## Findings with trying to assemble D1102029

Figure 1) D1102029 successful mating (not without concerns)

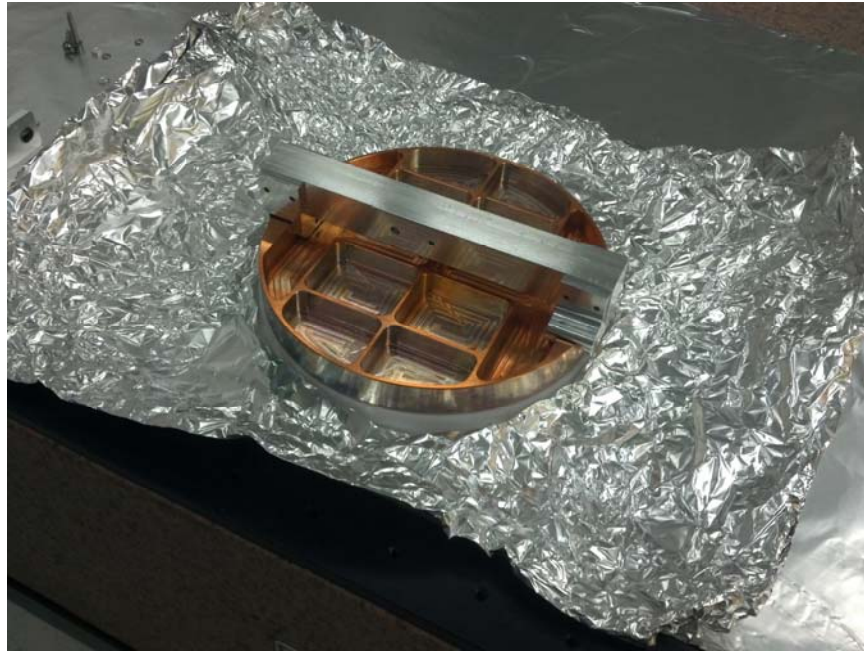
- 1) Of the two mirrors (D1101014) only SN 001 was able to mate with D1101294.
  - This mate was not smooth however and did require some force. It seems like the holdup was around the opening to the holes on the mirror itself (not deburred well enough?)

- I tried to show how the holes line up to one another but of course the angle of the picture is deceiving... screws can and were installed to show that they can mate to another. (I started testing other things and forgot to take a picture of the screws installed)

Figure 2) Holes align with force

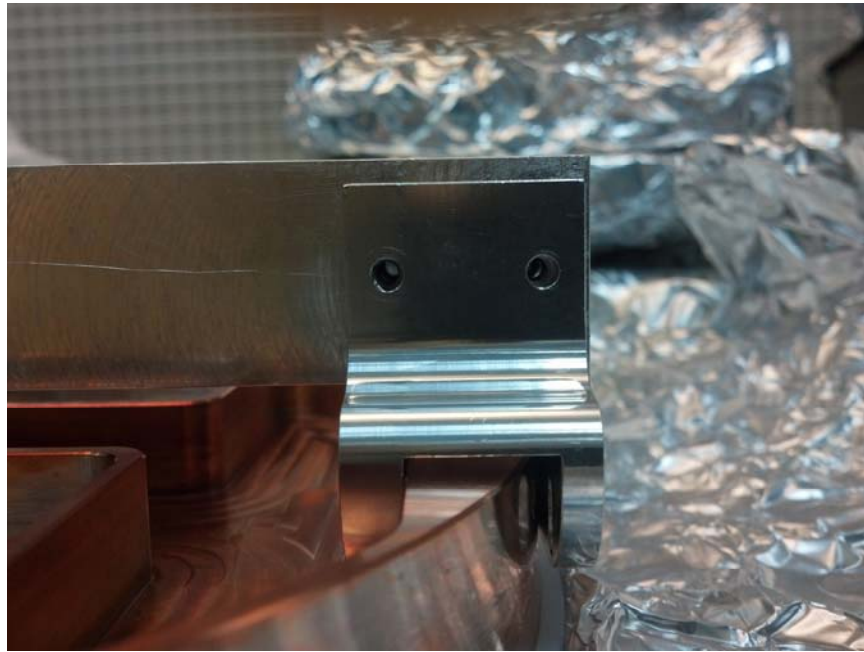
- D1101014-002 seems to have thicker walls making it much harder to force D1101294 on. I think it could be done but it will cause shedding of the metal and it will be hard to manipulate or pivot when we align (this shedding and pivoting problem is also a concern with D1101014-001 but not as critical)

Figure 6) D1101295 scarred from mating with D1101294

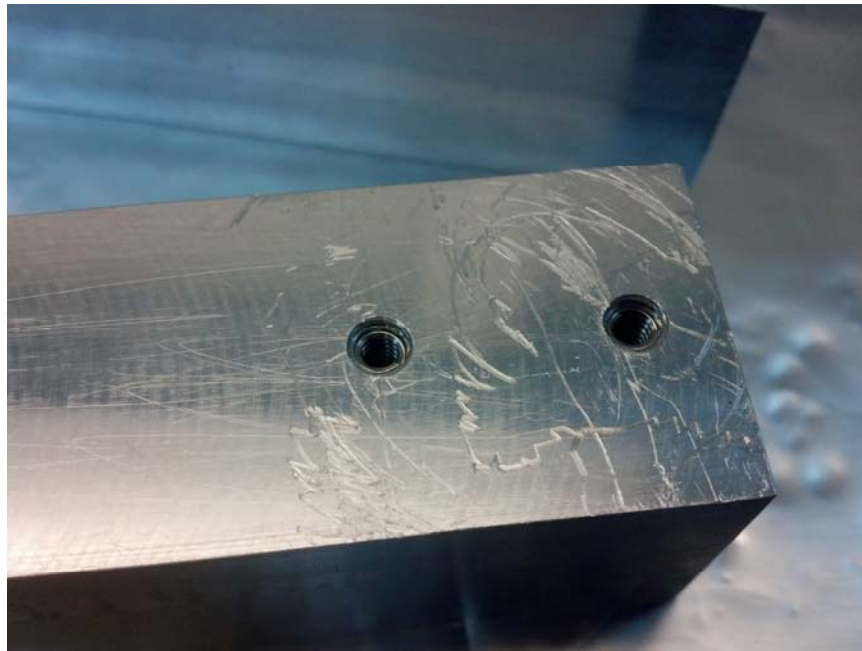
- 2) D1101294 successfully mated to D1101295 the first several times but isn't very repeatable. I think when I was trying to get the whole assembly together, the parts started rubbing tightly against another causing the scratches seen in the picture below. Towards the end of this fit check, it requires some strength to pull the two pieces apart from another...

SIZE: DWG. NO. D1101294

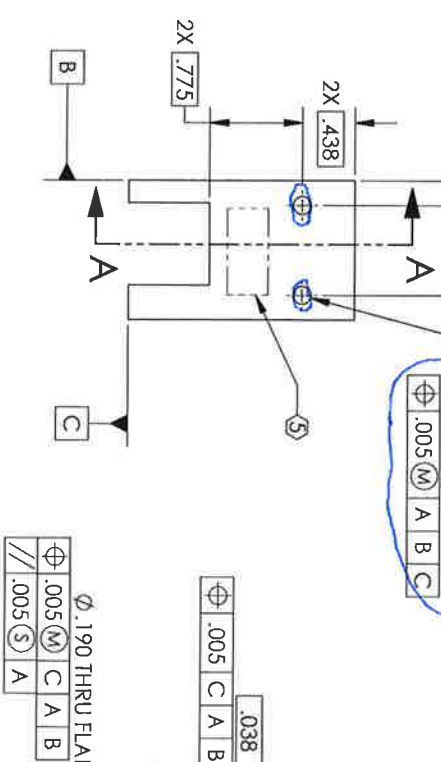
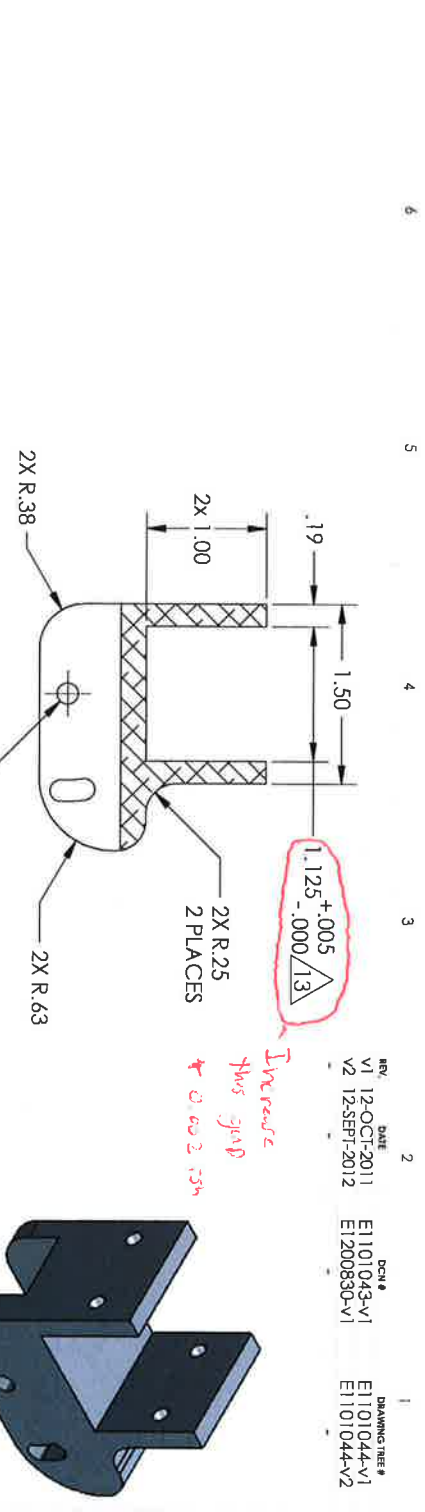
- I think the easiest way to solve these problems is to work on D1101294. Below is a marked drawing, but I would suggest for ease in the future that we open up the gap (again) on D1101294 where it mates with D1101295 as well as the gap that mates to the mirror by a few thousandths. These will allow for ease of pivoting as well as assembling.
- I would also suggest that we slot the holes to allow for any tolerance differences between the separation of the mating holes on D1101295 and the distance between the mirror walls. This isn't critical since I was able to get the screws in, but it was pretty tight.
- I also don't think any of these findings should hold up the ordering of the remaining SM1 mirrors (D1101014)
